# Planning Commission Agenda Item

**SUBJECT: SUP-51-2021 N. DECATUR / W. LONE MOUNTAIN RD (Public Hearing).**  
Applicant: Mike Bonanni / CONTOUR. Request: A special use permit in a C-1 (Neighborhood Commercial District) to allow a mini-warehousing establishment. Location: Southeast corner of Decatur Boulevard and La Madre Way. Ward 3

To: Sharianne Dotson, Planner, Land Development & Community Services  
From: Duane McNelly, Land Development Coordinator, Department of Public Works  
Subject: SUP-51-2021 **N. Decatur & W. Lone Mt. Road**  
Date: August 14, 2021

SITE PLAN

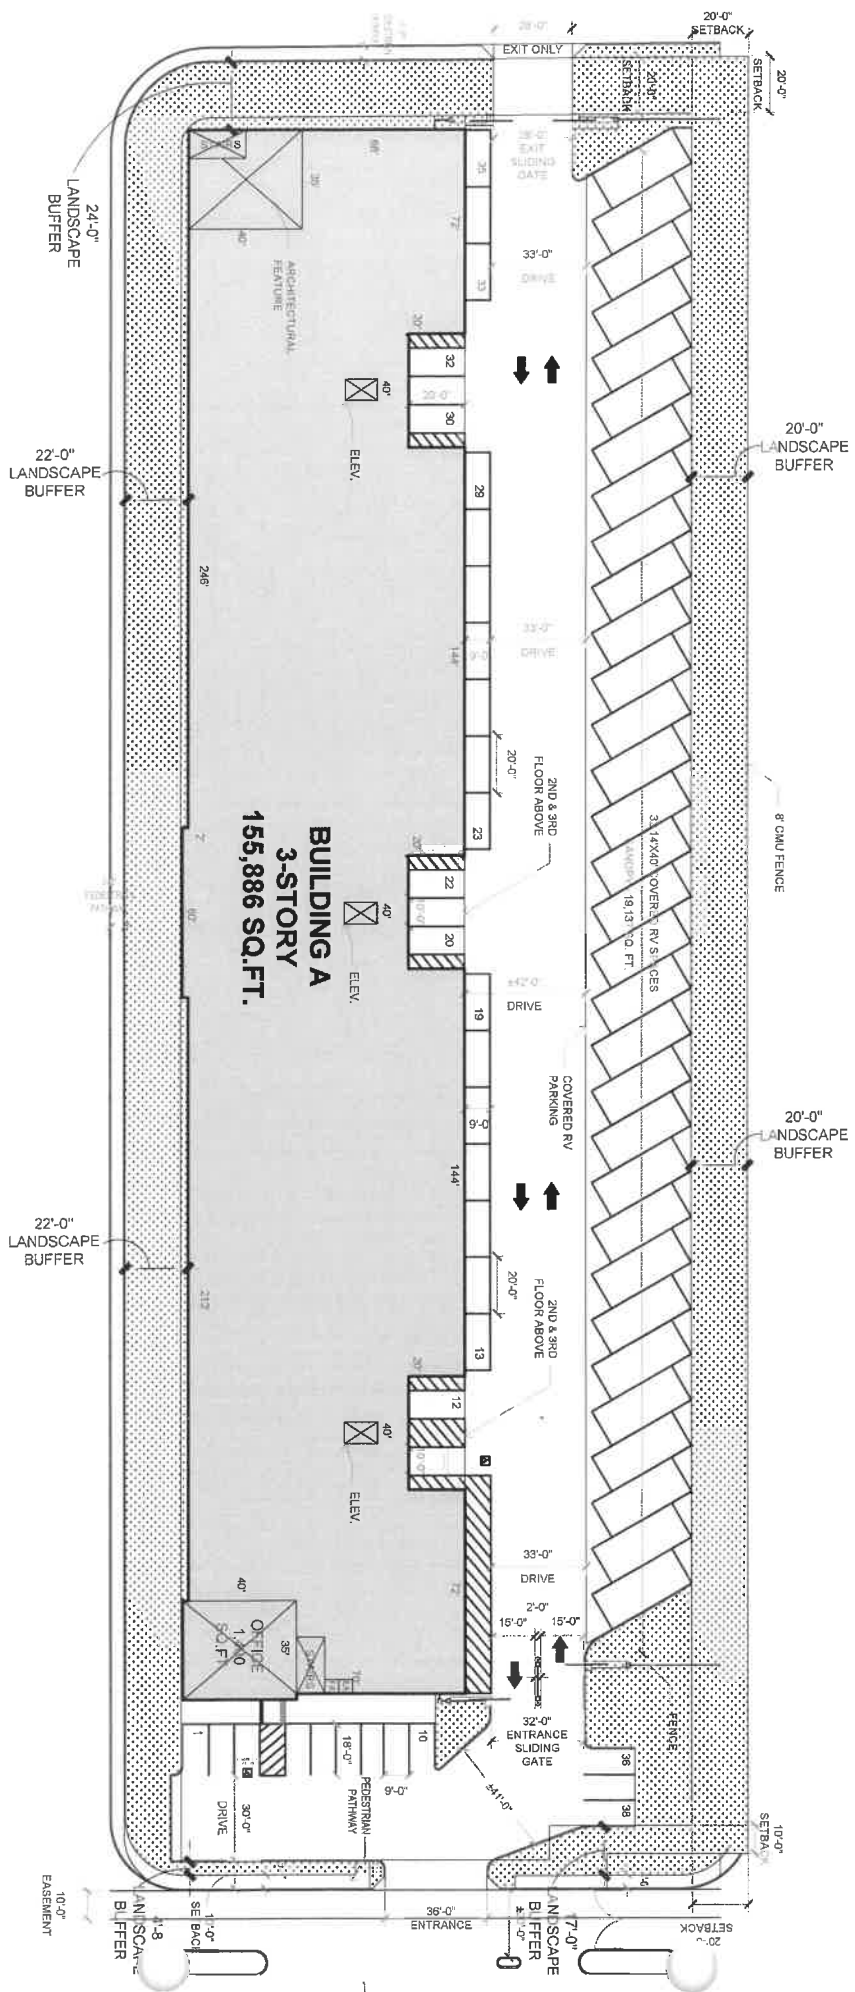
The proposed site plan does not indicate the required trash enclosure being provided. In addition, the enclosure is required to use similar materials and color palette as the principal building. Additionally, landscape islands are required on both sides of the trash enclosure. This can be addressed during the building permit process.

The applicant did not provide a landscape plan. The required landscaping is fifteen (15) feet including a five (5) foot detached sidewalk adjacent to Decatur Boulevard and La Madre Way. The proposed site plan shows 22 to 24 feet of landscaping with a five (5) foot sidewalk at back of curb adjacent to Decatur Boulevard and La Madre Way. The five (5) foot sidewalk is required to be within the landscaping and not permitted to be adjacent to the street. This is minor and can be addressed during the building permit process. The location of the building appears to combine perimeter landscaping with the requirement for foundation landscaping. No additional foundation landscaping will be required. The site plan shows the required 20 foot landscape buffer from adjacent residential property to the east. All areas to be landscaped should provide 50% ground coverage within two years of planting to comply with the municipal code.

The proposed site plan indicates a covered parking structure for 32 RV parking spaces located adjacent to the east property line. To help buffer the surrounding residential, all structures (including carports) are required to be setback 30 feet from the surrounding residential. The covered parking structure is only 20 feet from the existing residential property where 30 feet is required. The covered RV parking structure should be moved to meet the setback requirement or removed. This will be addressed during the building permit process.

Parking is calculated for mini-warehousing as one (1) space for every fifty (50) units plus five (5) customer spaces and two (2) spaces for the on-site manager. In addition, two (2) bicycle parking is required for the mini-warehousing establishment. The required bicycle parking is not shown on the site plan. The applicant has proposed 1,200 units which requires a total of 31 parking spaces. The current site plan has approximately 34 parking spaces adjacent to the proposed building. The parking for the mini-warehousing establishment is in compliance with the parking requirements. The missing bicycle parking can be addressed during the building permit process.

1. Unless expressly authorized through a variance, waiver or another approved method, this development shall comply with all applicable codes and ordinances.
2. All structures in a commercial zoning are required to be 30' from an existing residential property line.
3. Exterior shall be limited to automobiles, boats, or recreational vehicles. The outside storage of other goods or materials shall be prohibited.
4. Applicant shall provide the (2) bicycle parking stalls.

5. The site plan shall be revised to provide the five (5) foot sidewalk detached and centered between perimeter landscaping along Decatur Boulevard and La Madre Way.
6. Applicant shall provide a trash enclosure. The trash enclosure shall use similar materials and color palette as the principal building with six (6) feet landscape islands are required on both sides of the trash enclosure
7. Applicant shall raise the existing CMU wall at the east property line adjacent to existing residential to eight (8) feet.

# STORAGE BUILDING ELEVATIONS

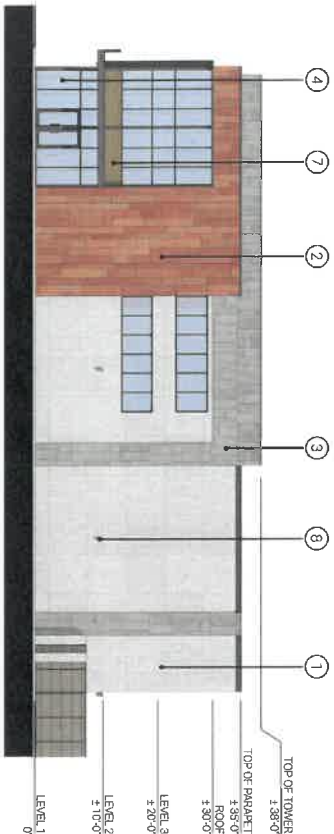
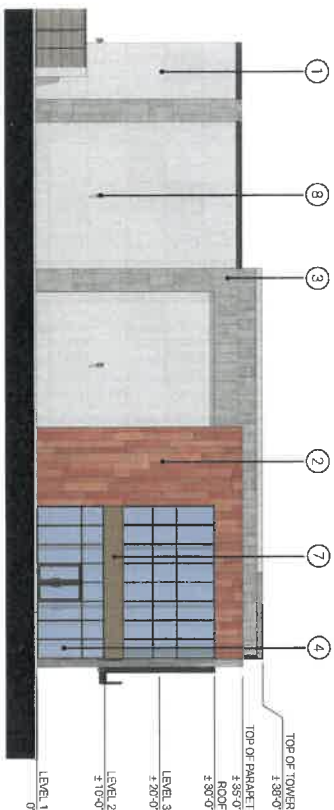
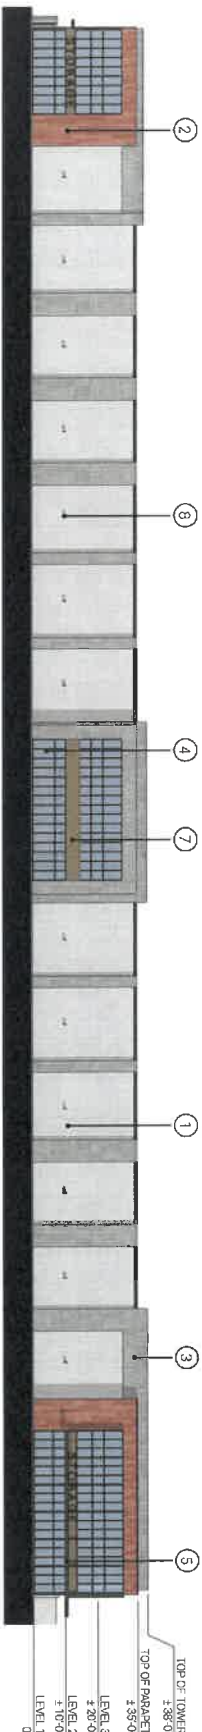
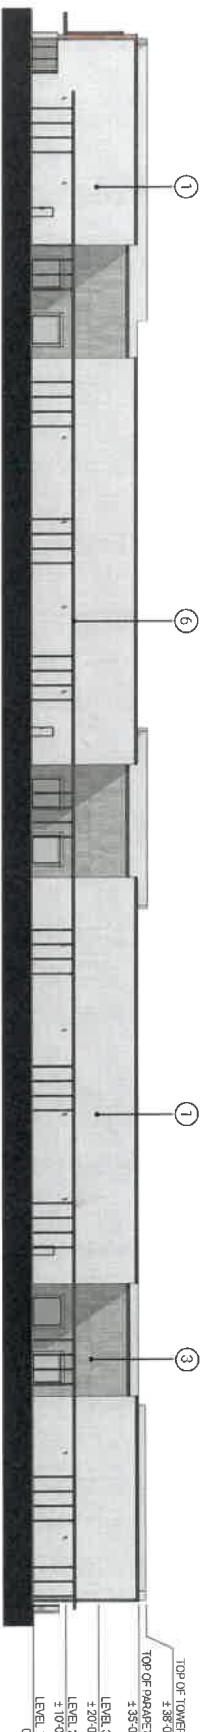
The applicant has provided building elevations of the proposed mini-warehousing establishment. The proposed building elevations show a 35 foot high 3-story stucco

building with a 3' cornice element on all four (4) sides. The building is painted a light gray with darker gray concrete columns and exterior lights. The proposed accent features consist of a rust colored terra cotta accent panel on the south and west elevations; metal rollup doors along the east elevation, a metal canopy over the entrance on the west elevation. Additionally, the north, south and west elevations show a wood paneling accent between the windows of the building. The architecture design and colors appear to be in compliance with the commercial design standards. The site plan notes a fence. This is the existing block wall for the residence to the east which will remain in place. The applicant should raise the wall to eight (8) feet for a commercial use adjacent to existing residential.
